NS32332 CPU REVISION C

January 21, 1987

This is the new user information sheet for the NS32332 Rev C.

NS32332 CPU Revision D

Figure 1

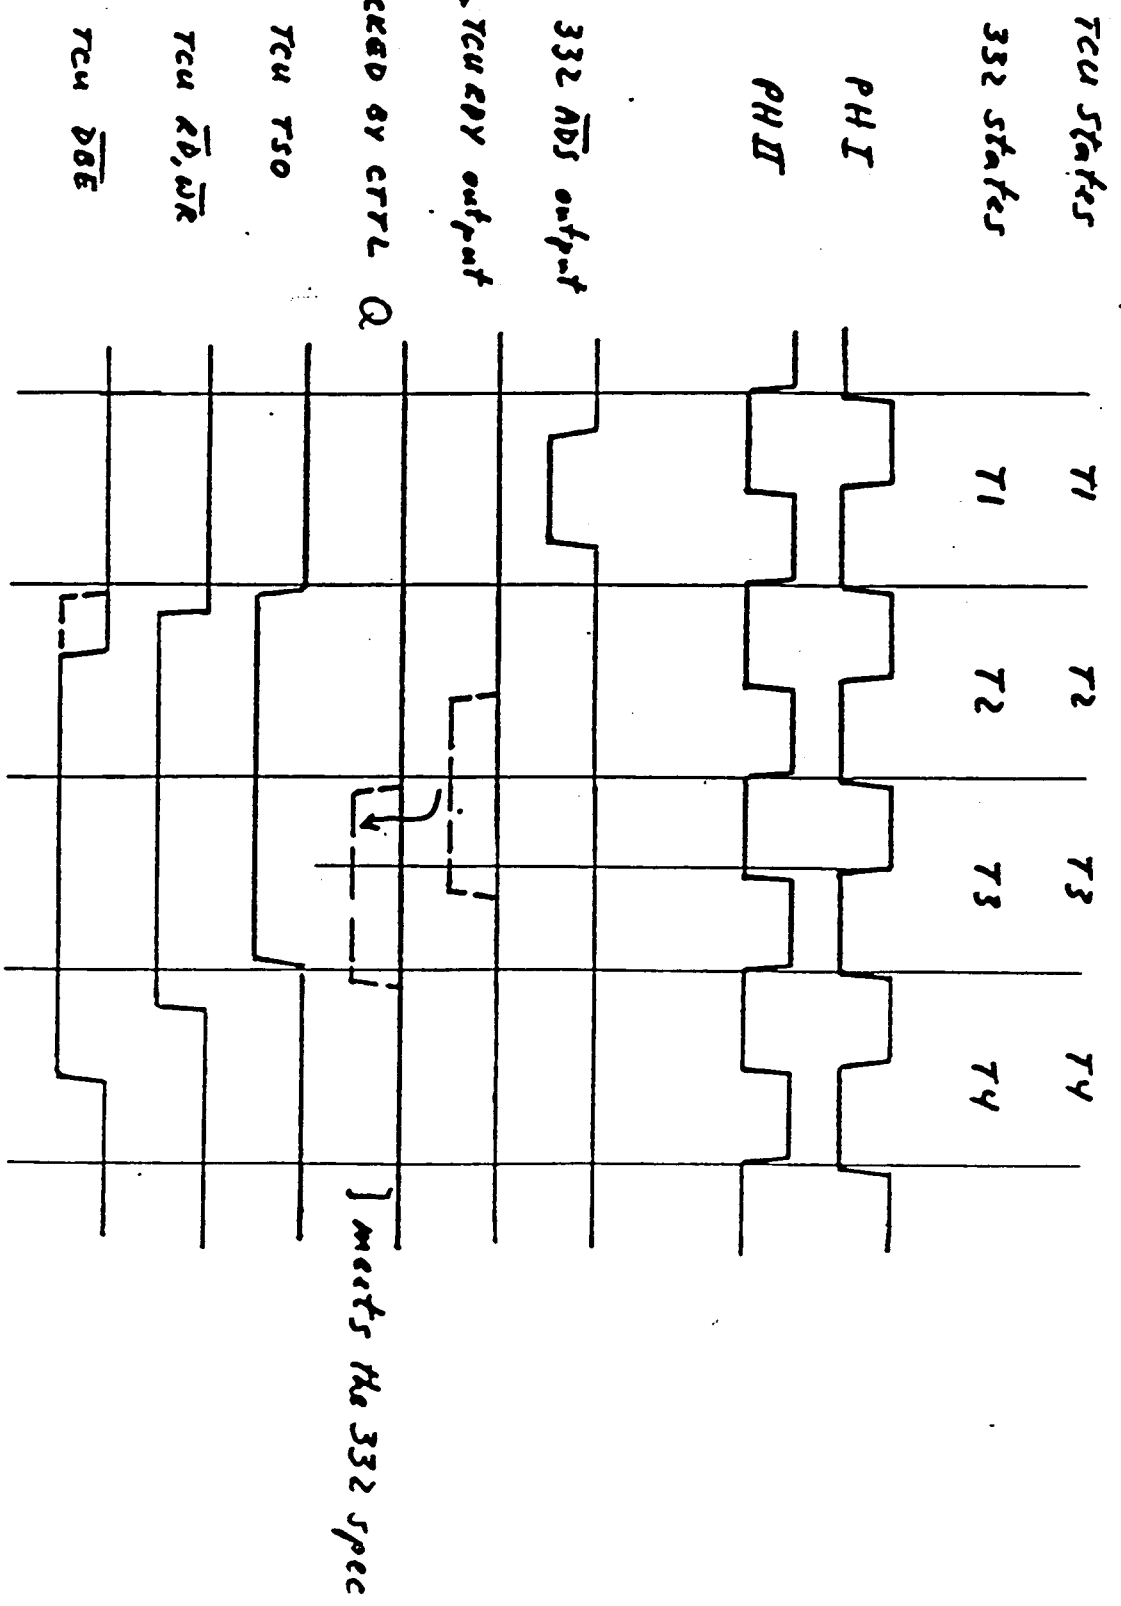
In a configuration without an MMU, TCU and CPU both run a four clock cycle bus (figure 1). The RDY signal is the only incompatible signal between the CPU and the TCU and therefore the RDY output of the TCU should not be directly connected to the RDY input of the NS32332. The NS32332 samples its RDY input in the middle of T3 while the NS32201 asserts its RDY output shortly after the middle of T2 and removes it shortly after the middle of T3, thus the NS32332 RDY input hold time (t_{RDYh}) is not met. To meet t_{RDYh} , the RDY output of the NS32201 should be clocked by the rising edge of the CTTL using a D type flip-flop (74AS74) and then taken to the NS32332. It should be noted that the NS32332 outputs the data in a write cycle in T3 unless DT/SDONE pin is sampled low on the rising edge of the reset in which case the data is output during T2. The DT/SDONE pin is implemented as of revision B of the NS32332.

Figure 3

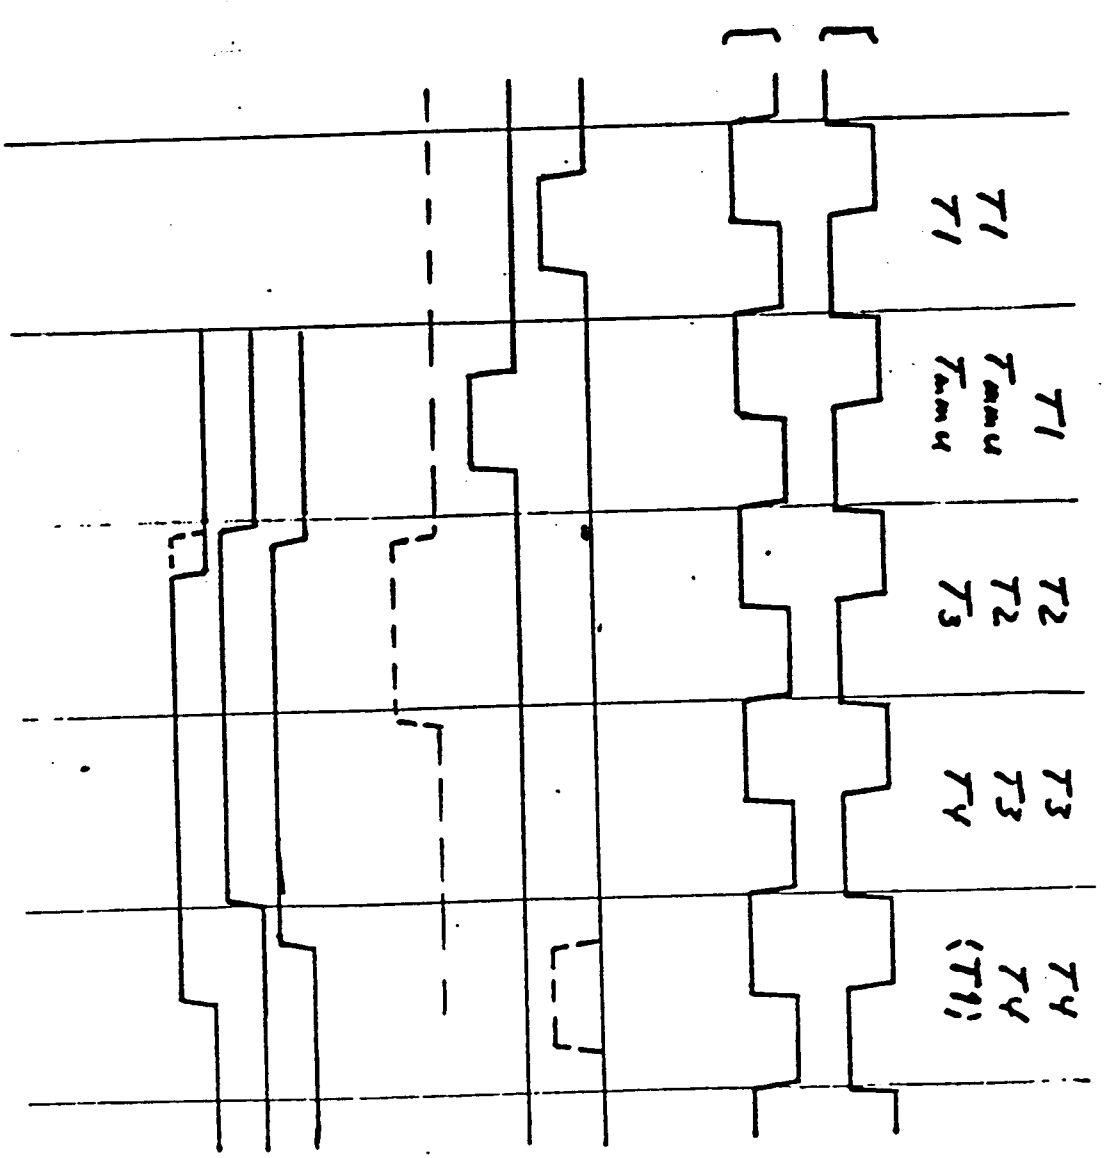
The second option is to have the NS32332 run a four clock cycle bus (figure 3). In this configuration the NS32201 output signals can not be used to interface the NS32332 to memory or I/O; they can only be used to interface the NS32082 to the memory. In this configuration a revision N of the NS32082 should be used.
